State of Alaska  
Department of Fish and Game  
Sportfish Division

Nomination Form  
Anadromous Waters Catalog

Region Southeastern USGS Quad(s) JUNEAU A-6  
 Anadromous Waters Catalog Number of Water Body 114-23-10700-2005  
 Name of Water Body \_\_\_\_\_  USGS Name  Local Name  
 Addition  Deletion  Correction  Backup Information

## ROUTE CORRECTION

Figure 1.—Stream No. 114-23-10700-2005 Route Correction.

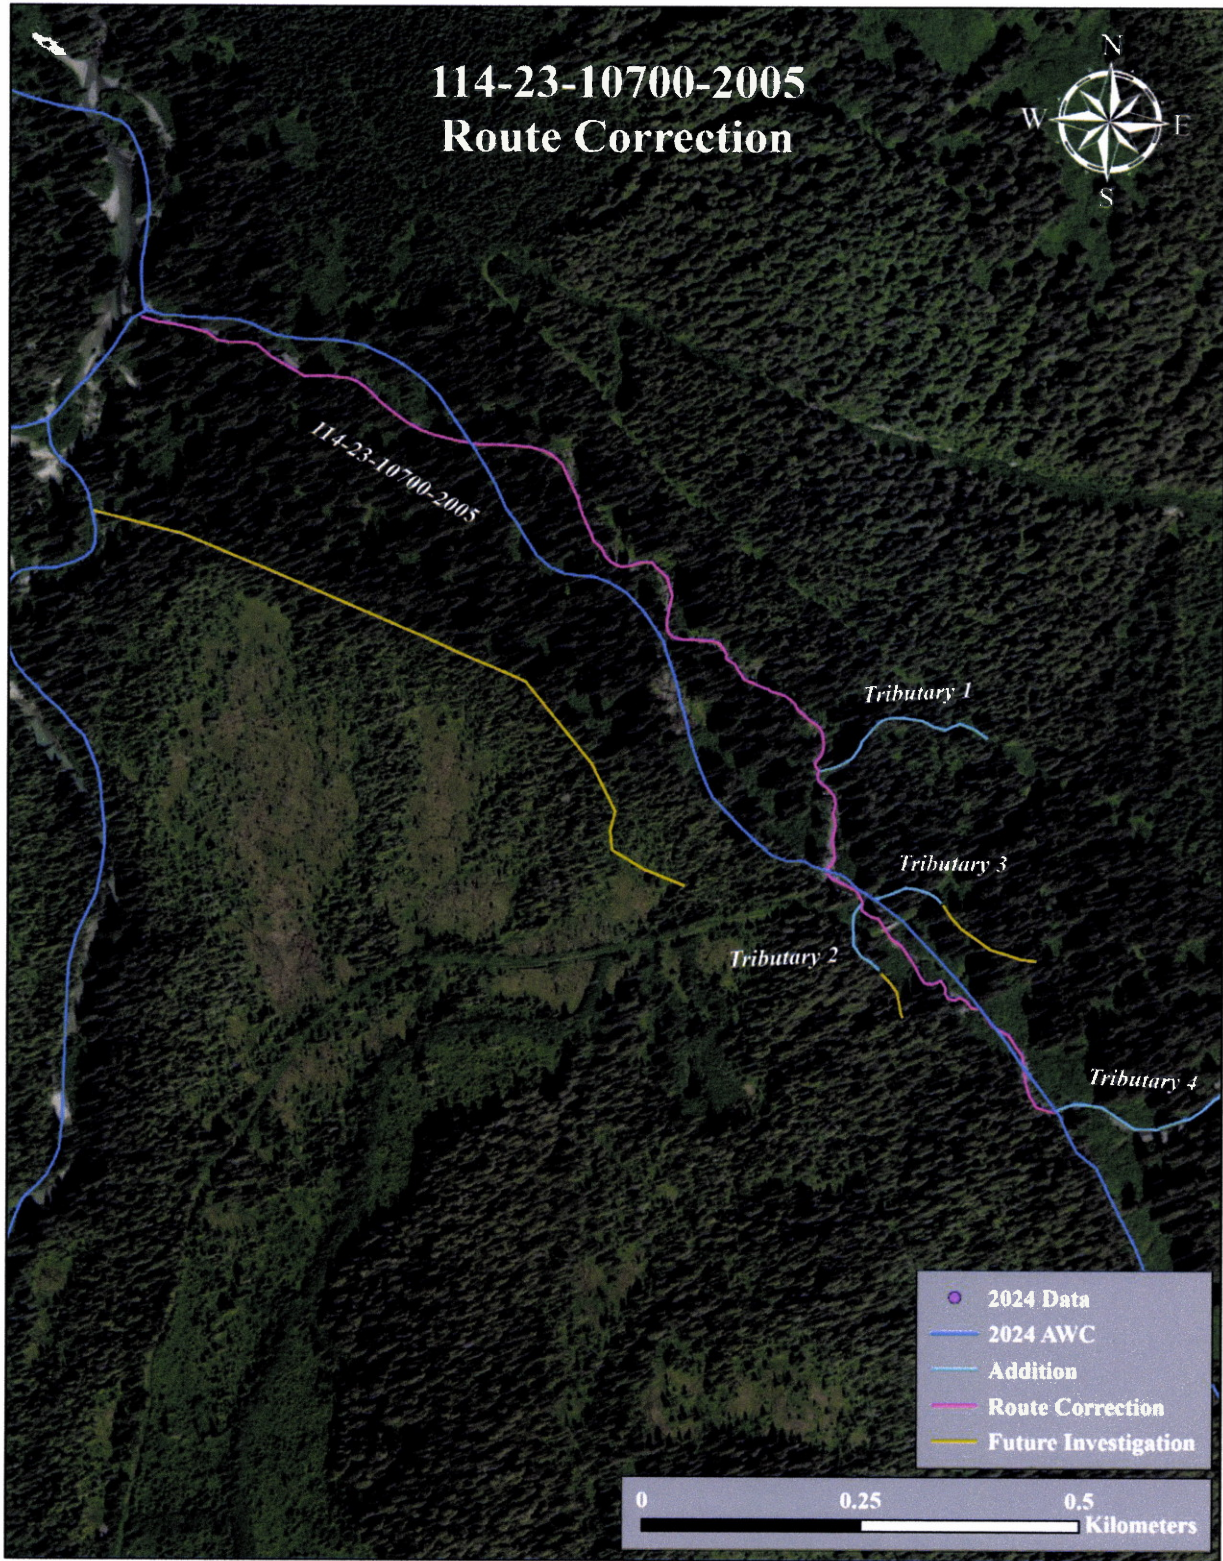
**Findings:** We surveyed this cataloged stream using a GPS and found that the stream path is incorrectly mapped. No data points or photos were taken during this survey but based on GPS tracking while walking the stream and satellite images, it was determined that the current stream path is incorrect.

**Recommendations:** Correct Stream No. 114-23-10700-2005 in the anadromous waters catalog to reflect the field verified stream path (Figure 1).

**Map #1**

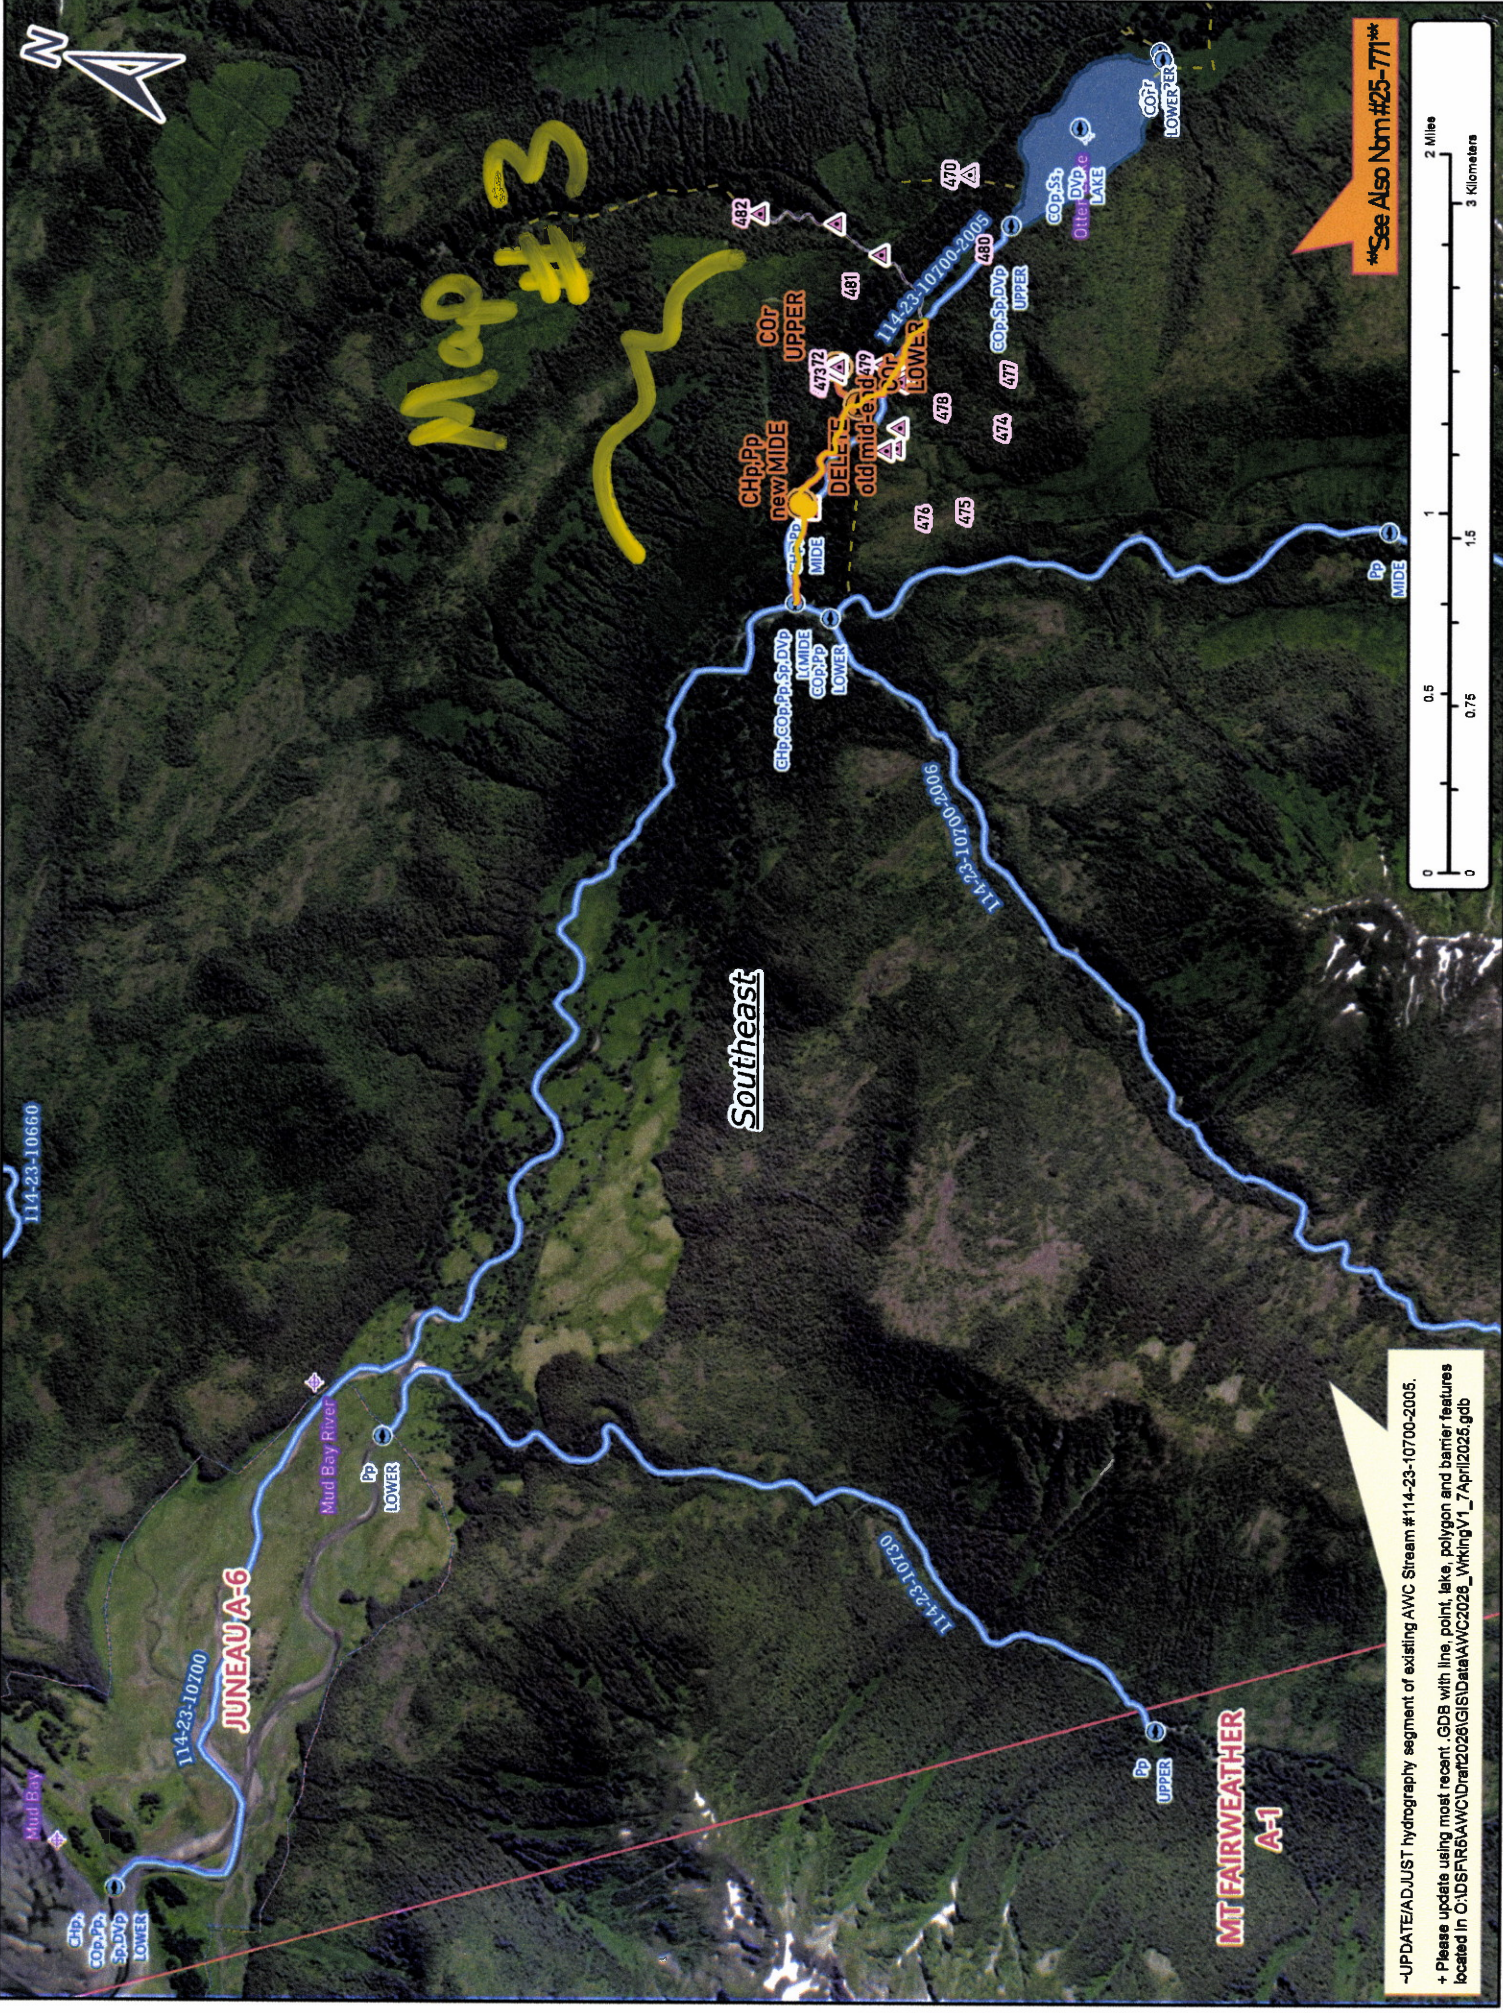
-UPDATE/ADJUST hydrography segment of existing AWC Stream #114-23-10700-2005.  
+ Please update using most recent .GDB with line, point, lake, polygon and barrier features located in O:\DS\FR\5\AWC\Drain\2026\GIS\Data\AWC2026\_WrkingV1\_7\_April2025.gdb

Map #2

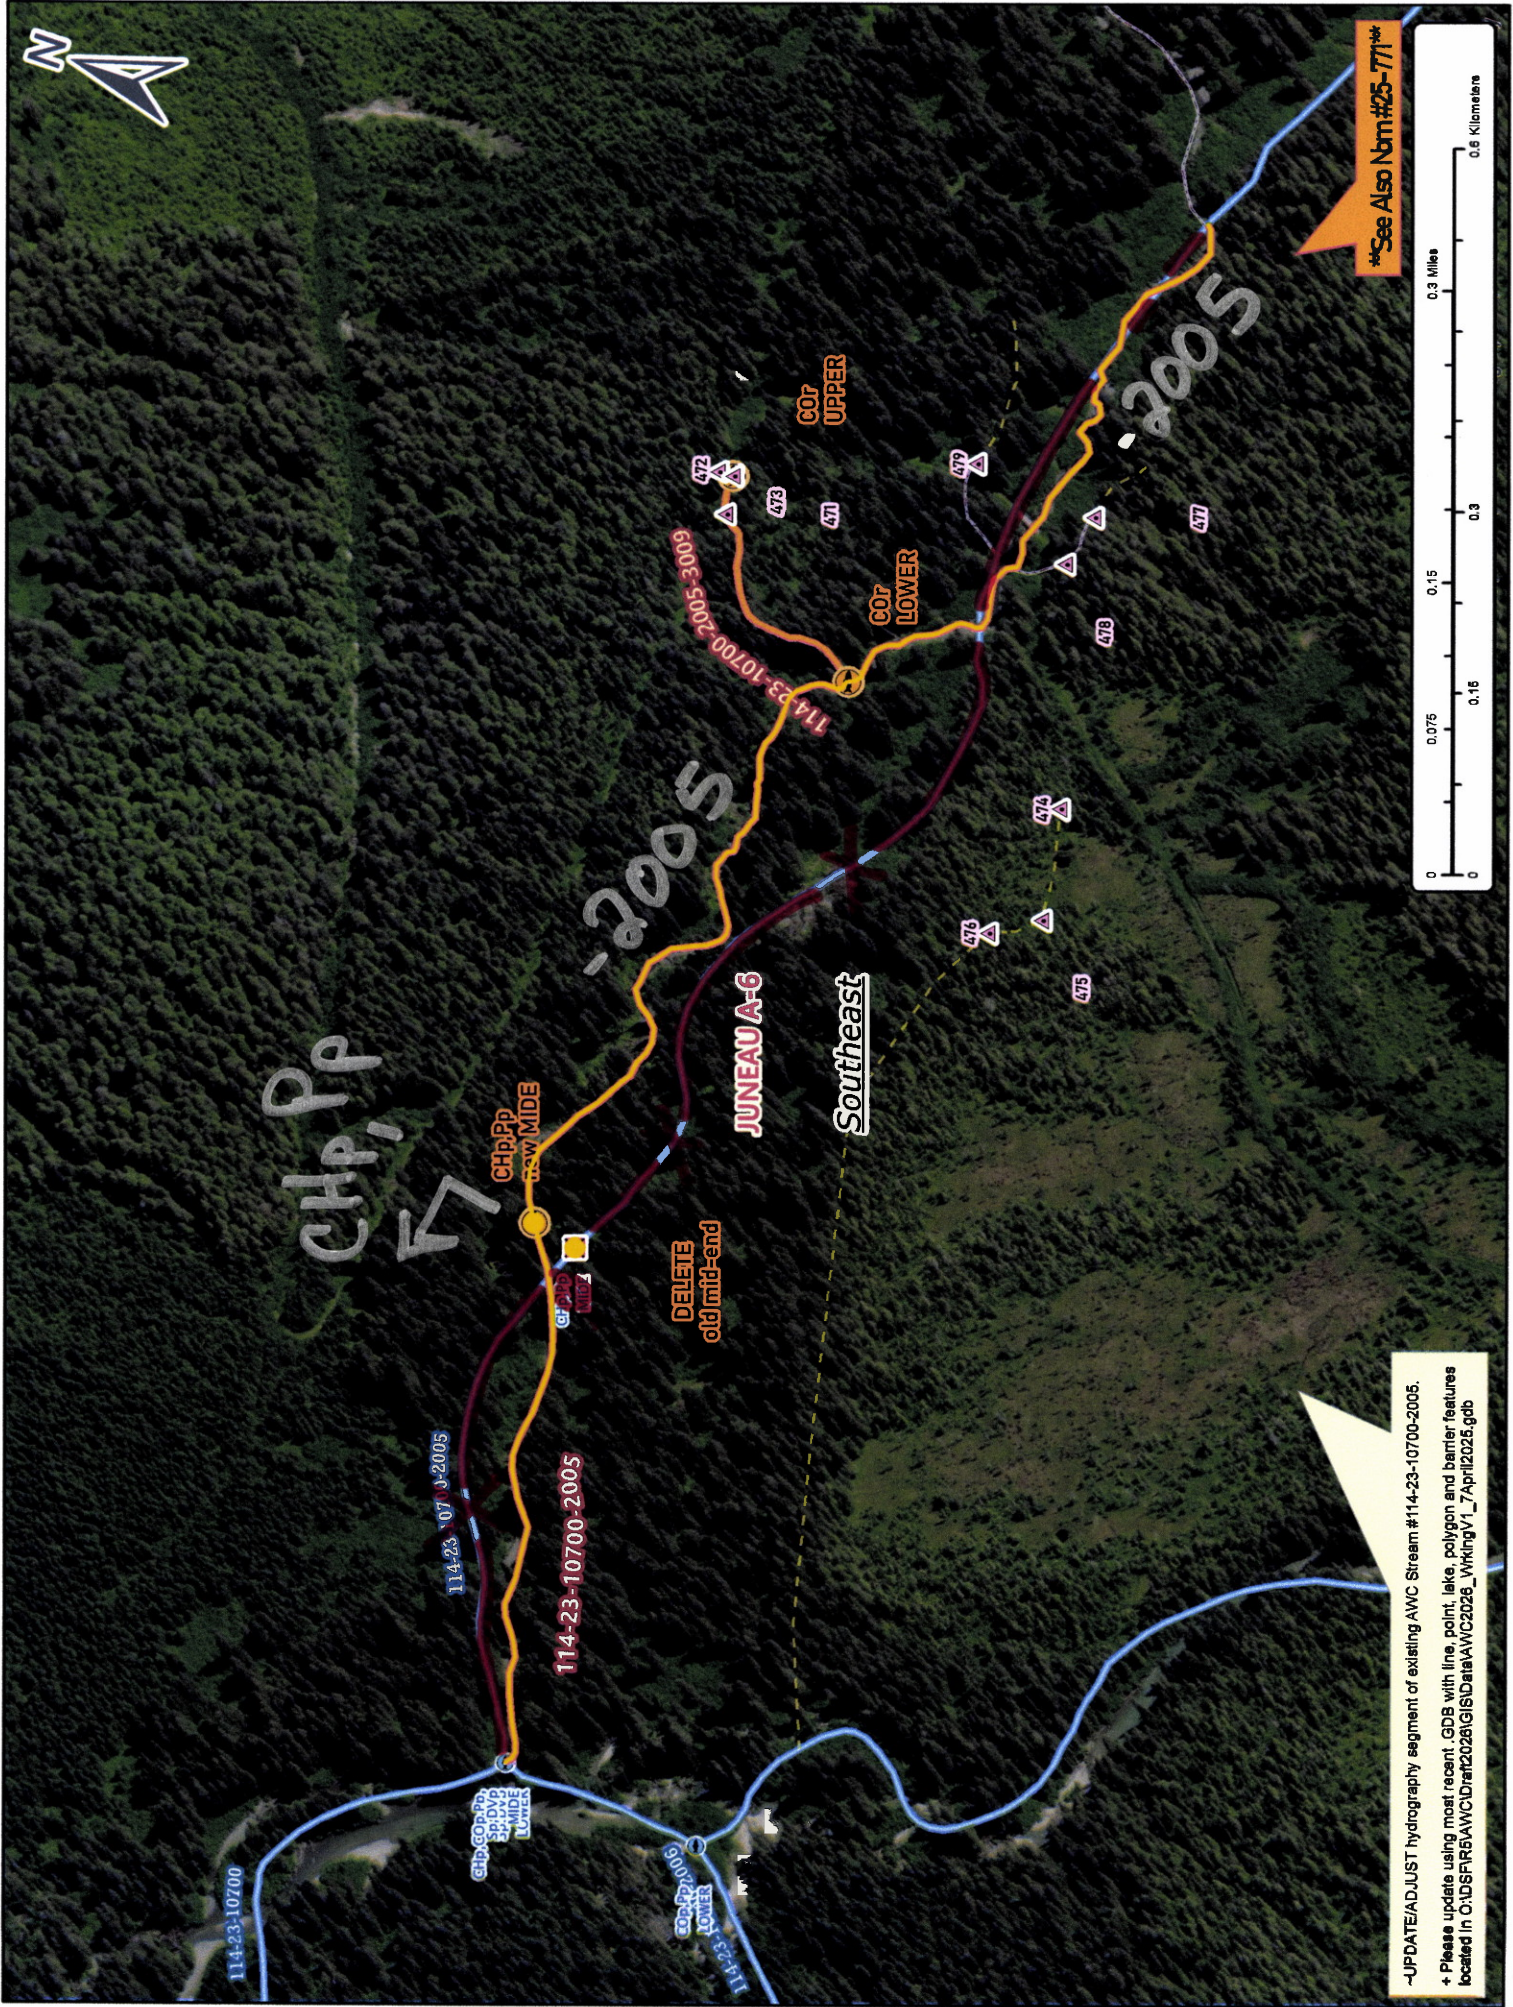
-UPDATE/ADJUST hydrography segment of existing AWC Stream #114-23-10700-2005.  
+ Please update using most recent .GDB with line, point, lake, polygon and barrier features located in C:\OSFR\AWC\Drain\2026\GISData\AWC2026\_WorkingV1\_7April2026.gdb
